DECISION OF THE PLANNING COMMISSION

FAIRVIEW REFINEMENT PLAN MAJOR AMENDMENT CASE NO. FRPA16-01

SUBJECT: SUPPLEMENTAL STAFF REPORT REGARDING FAIRVIEW REFINEMENT
PLAN MAJOR AMENDMENT CASE NO. FRPA16-01

SUBJECT: PUBLIC WORKS RECOMMENDATIONS
FRPA 16-01 (16-105264)
2250 OLD STRONG ROAD SE
AMENDED FAIRVIEW REFINEMENT PLAN II

Plate 5 shows the types and locations of the new streets. Typical cross sections of streets are shown on plates 6.1-6.4

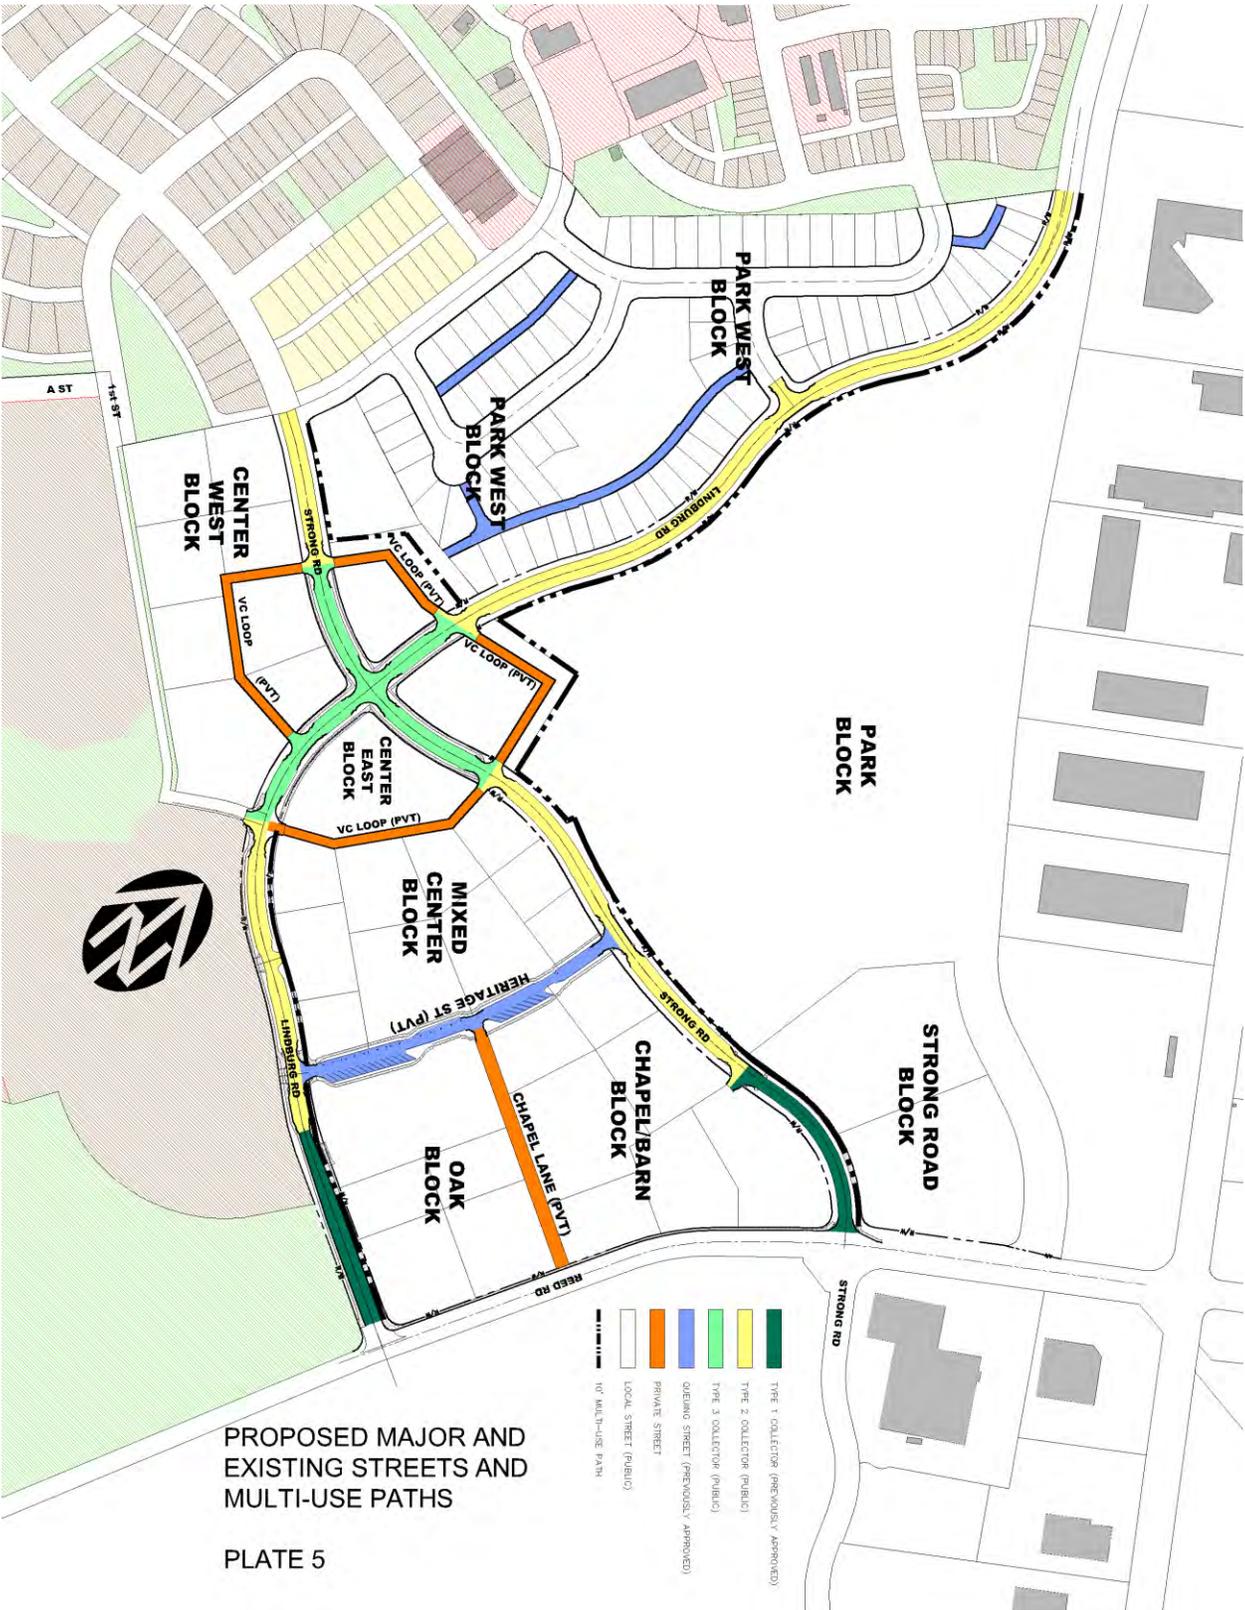
Condition 6: The proposed major and existing streets and multi-use paths plan (Plat 5) shall be revised to show a multi-use path connection between the multi-use path along Lindburg Road and the multi-use path along Strong Road.

- f. 1st Street SE terminates at the southwest corner of the subject property and is not clearly depicted in Plate 5 of the refinement plan. The applicant shall modify the plan to show how 1st Street SE integrates into the street plan.

Typical Street Sections

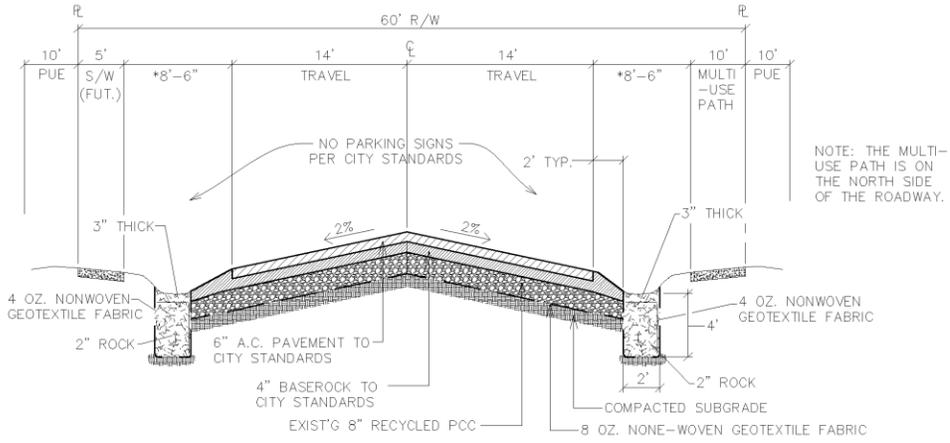
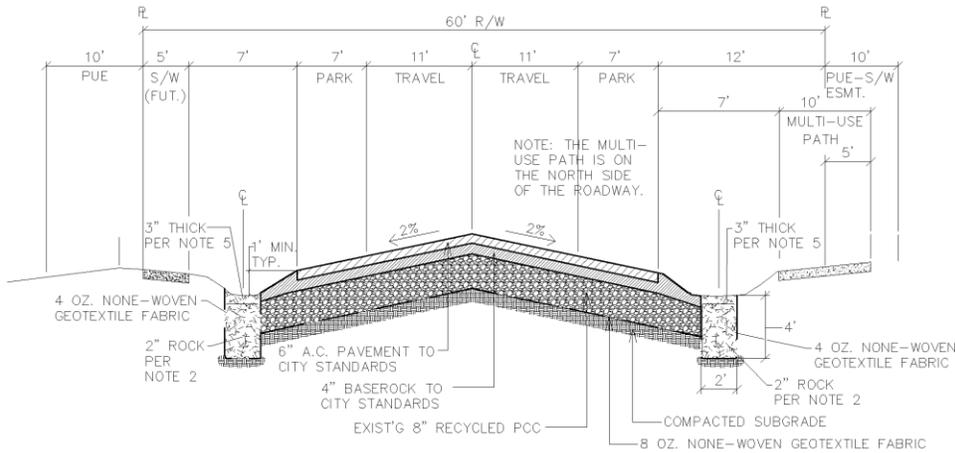
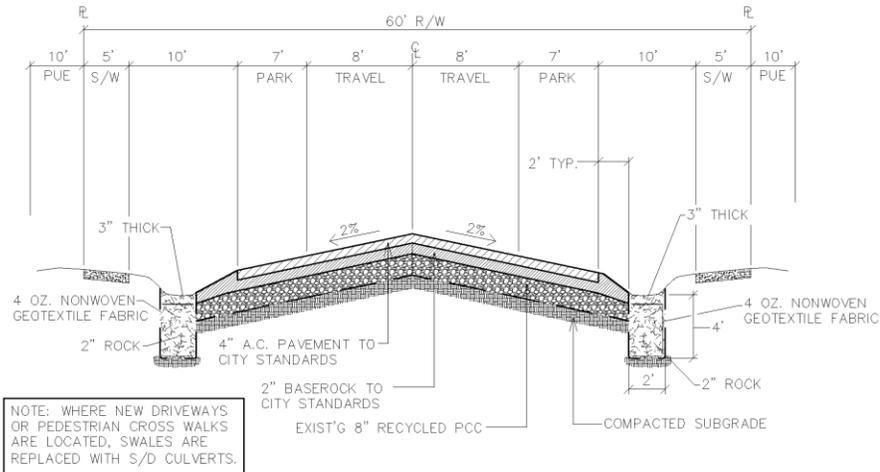
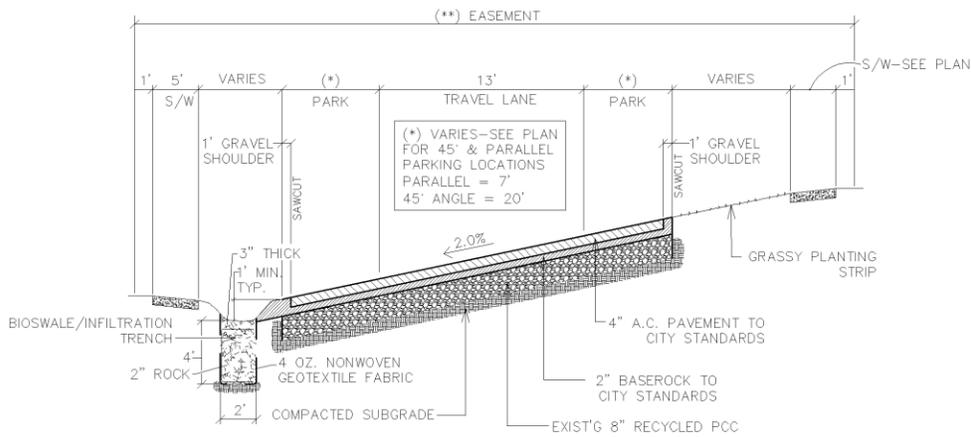
Condition 10: Section 6 (Typical Street Sections) of the amended refinement plan shall be revised to include a cross section for the alleys proposed within the amended refinement plan.

- g. Many of the street sections do not appear to provide adequate space for street trees, and the application materials do not show how requirements of SRC Chapter 86 are being met. The applicant shall provide a street tree plan or otherwise demonstrate how the proposed street widths comply with SRC Chapter 86 and shall amend the street sections if needed to accommodate for street trees.

TYPE 3 COLLECTOR STREET – (PUBLIC)
 NTS
 SEE PLATE 6.0 FOR PROPOSED CURB EXTENSIONS

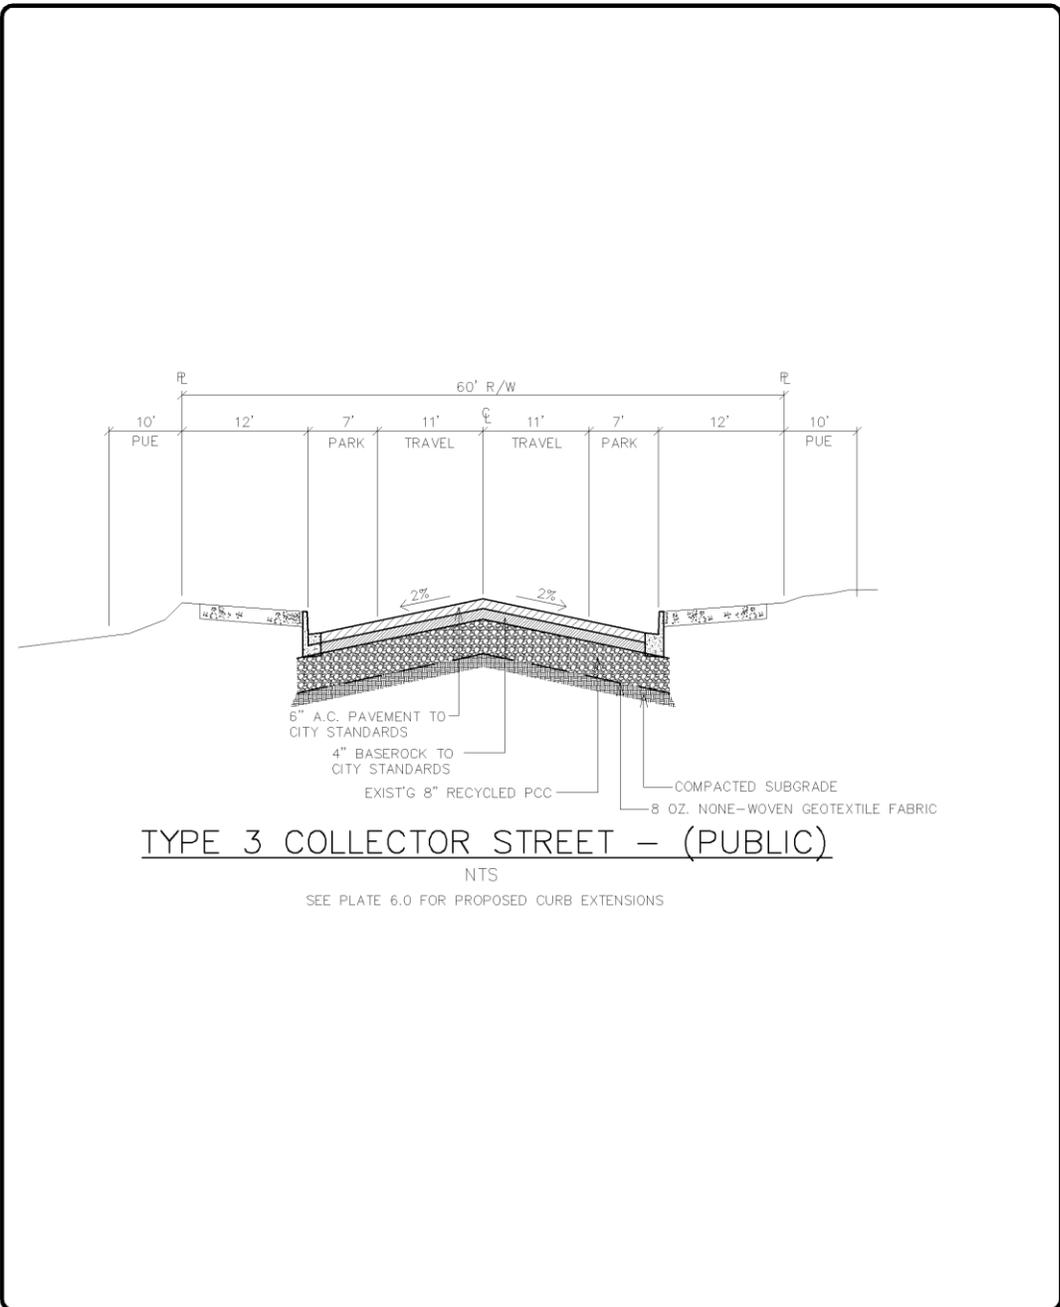
Condition 7: The Type 3 Collector Street shall include "sharrows" striping and signing to accommodate safe bicycle travel.

REED ROAD – (PUBLIC)
NTS

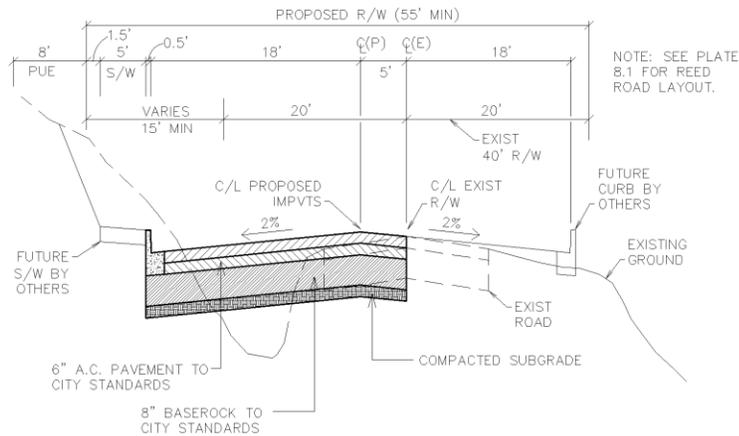
Condition 1. The street improvement along Reed Road shall be a minimum 23-foot-wide half-width improvement within a 36-foot-wide half-width right-of-way to meet minor arterial street standards.
